Kosmek Ltd.

## Announcement of Sales Launching of New Speed Control Valve (Model BZL)

#### 2. On compatibility with regard to dimensions and installation

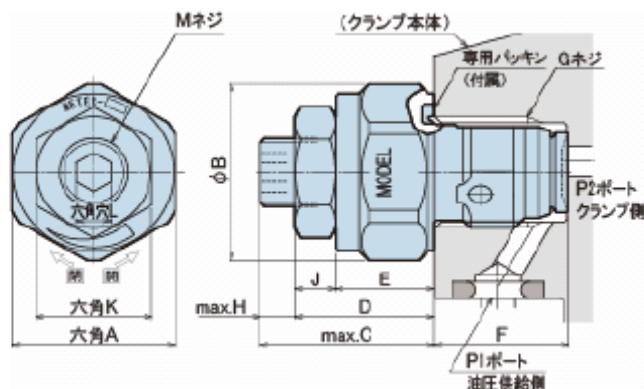
Meter in type    BZA0□0    ⇒    **BZL0□00-A**

Meter out type    BZB0□0    ⇒    **BZL0□00-B**

All types are compatible with each other for installation.

However, as the protrusion from the mounted cylinder surface is increased by 4.5mm, please take special care with regard to interference.

\* max.C/D/E/max.H sizes are added.
